**RE: Economic and Technical Analyses of the Most Severe Single Contingency (MSSC)**

# Most Severe Single Contingency Evaluation

An Evaluation and Review of the 'Most Severe Single Contingency' Level  
on the Alberta Interconnected Electric System

**Figure 1 – BC and MATL ATC and Flows vs. Pool Prices (January to September 2021)**

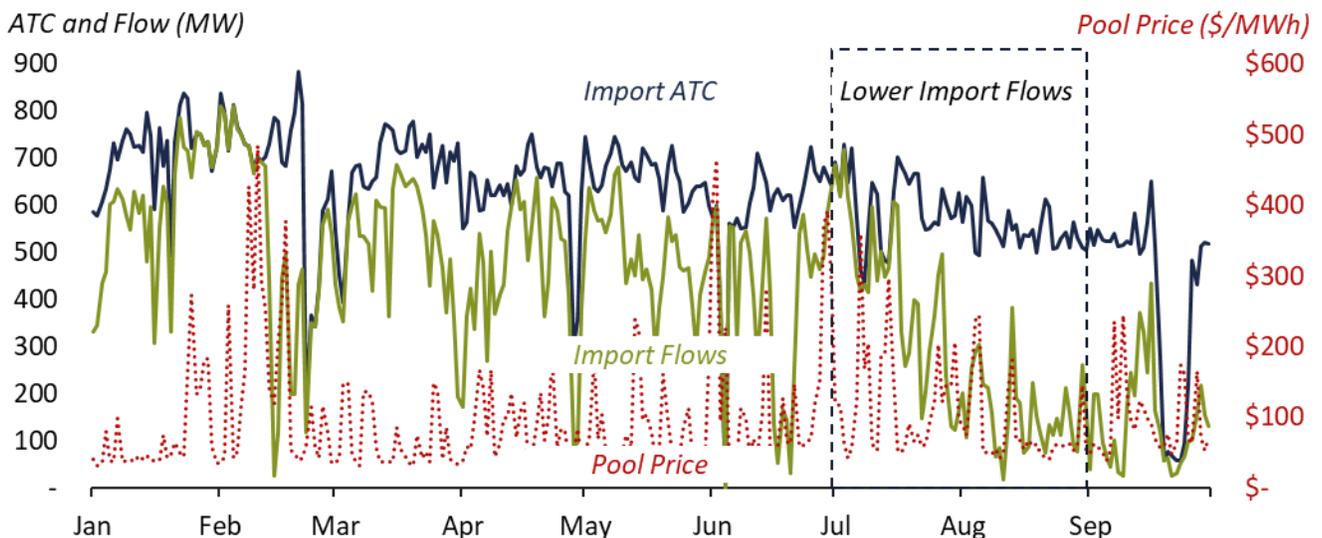
One underlying assumption made by the AESO in their counterfactual analysis is that tie-line flows are equivalent to zero dollar offers. While import offers into the energy market are priced at zero dollars, the offer volume is an economic decision (imports are not subject to the must-offer rule) that considers the expected pool price of Alberta. Evidence of this is observed in Figure 1, which shows the ATC and import flows for the BC and MATL tie-lines from January to September 2021 (from mid-July to the end of August, the flows dropped in response to higher Mid-C prices).

The decision in front of the AESO is not to reduce the ATC of the BC and MATL tie-lines in isolation, but to increase the MSSC value to accommodate larger generating units, specifically, the two Genesee repowered combined cycle units. The Genesee repowered combined cycle units are impacted by the 466 MW MSSC level due to their large size and 1-on-1 configuration, which as will be shown in later sections is the most economically efficient. This report offers a broader forward-looking analysis that considers the price impact of adding 2 MW of 6,700 kJ/MWh heat rate generation into the Alberta supply mix for every 1 MW reduction in the ATC of the BC and MATL tie-lines.
